UNITED STATES PATENT AND TRADEMARK OFFICE

APPLICATION NO.	FILING DATE	FIRST NAMED INVENTOR	ATTORNEY DOCKET NO.	CONFIRMATION NO.
09/977,528	10/12/2001	James Hong	ACS 57818	4201

Office Action Summary

DETAILED ACTION

See the attached Figure 6 for the structural limitations of the claimed stent.

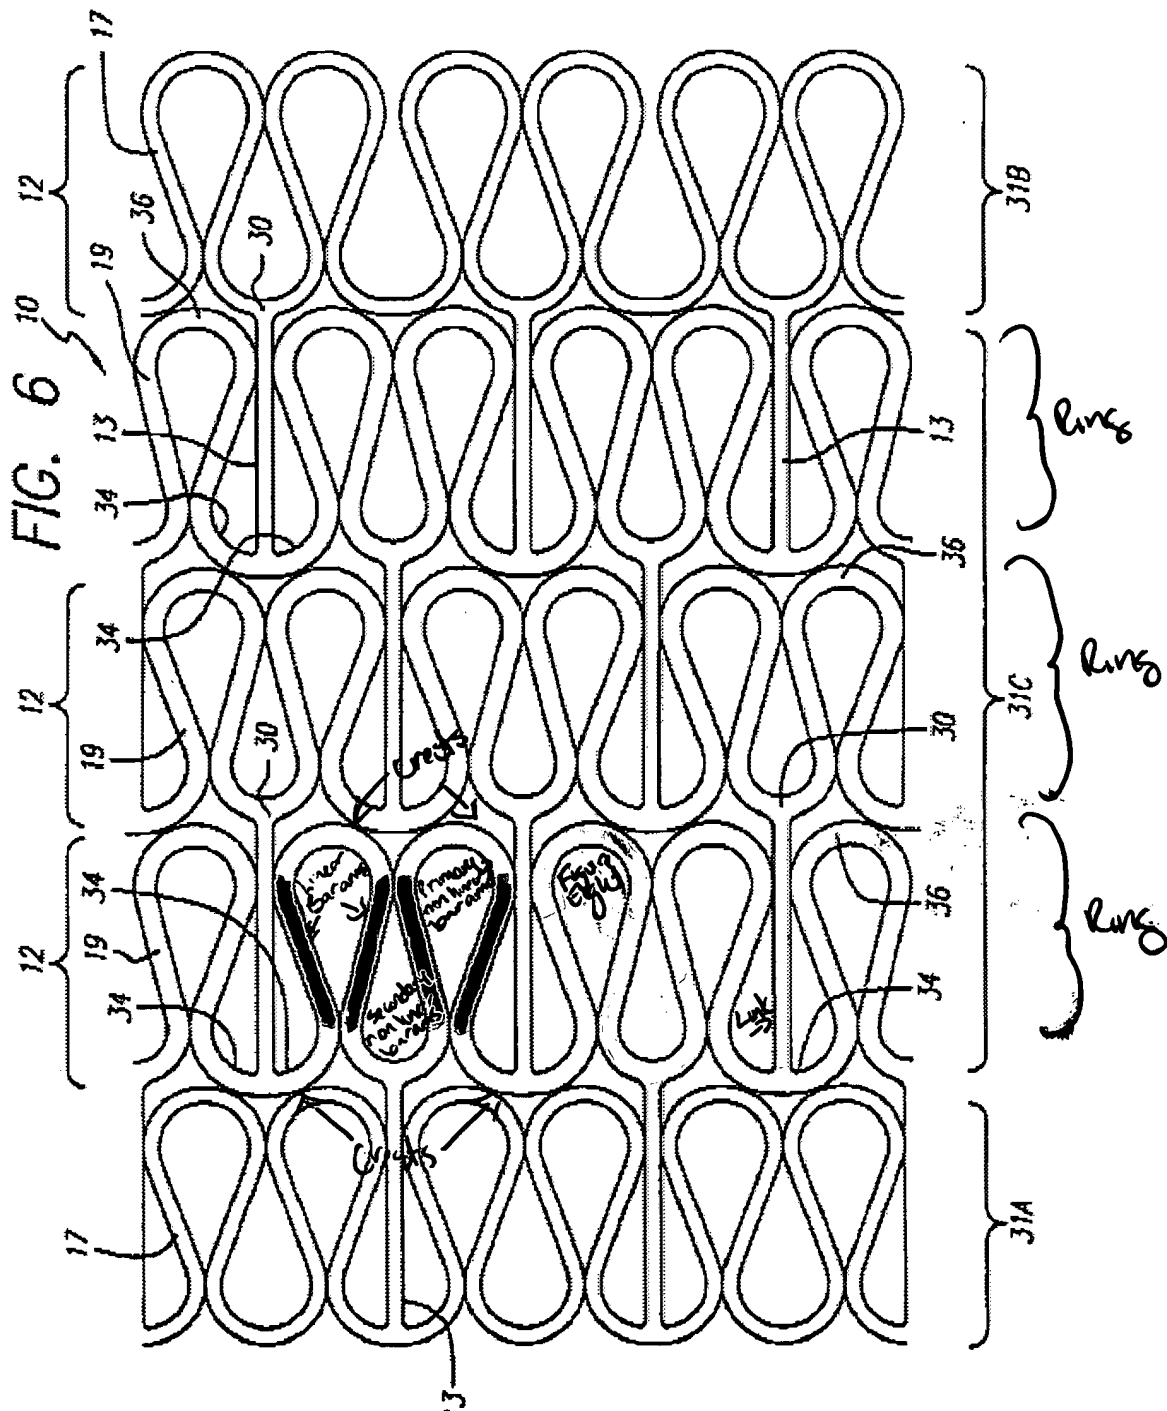
5. Claims 1, 2, 5-11, 13-20 and 30 are rejected under 35 U.S.C. 102(e) as being anticipated by U.S. Patent No. 6,273,911 to Cox et al.

10. Applicant argues that Cox '911 does not show adjacent linear and nonlinear bar arms defining the crests. It is unclear from the applicants' arguments what is not shown in the attached Figure 6. As shown above, Cox has adjacent linear and nonlinear bar arms defining the crests. Therefore, the rejection over Cox et al. '911 is proper.

See attached Figure 4 for the claimed structural limitations of the claimed stent.

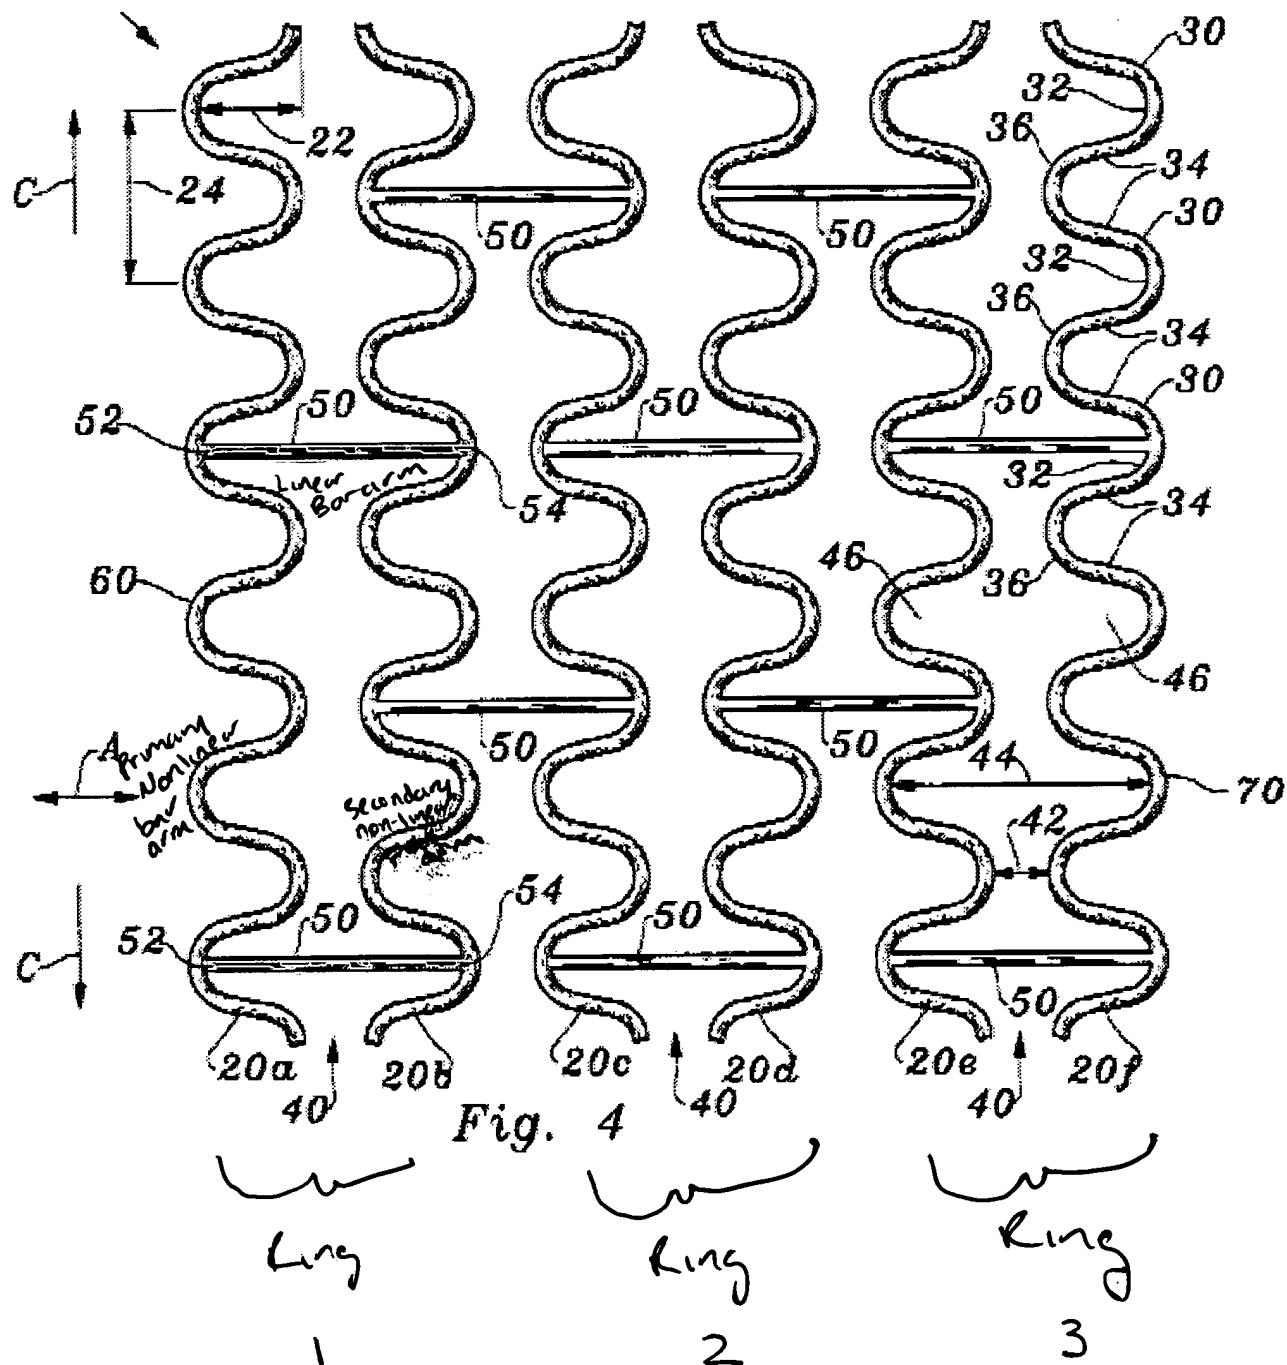
6. Claims 1-4 are rejected under 35 U.S.C. 102(b) as being anticipated by U.S. Patent No. 5,843,175 to Frantzen.

11. Applicant argues that Frantzen '175 does not show "a repeated series of at least three adjacent ring portions configured in substantially the same orientation throughout the stent." As shown above, the attached Figure 4 of Frantzen includes at least three rings in substantially the same orientation. Therefore, the rejection over Frantzen '175 is proper.
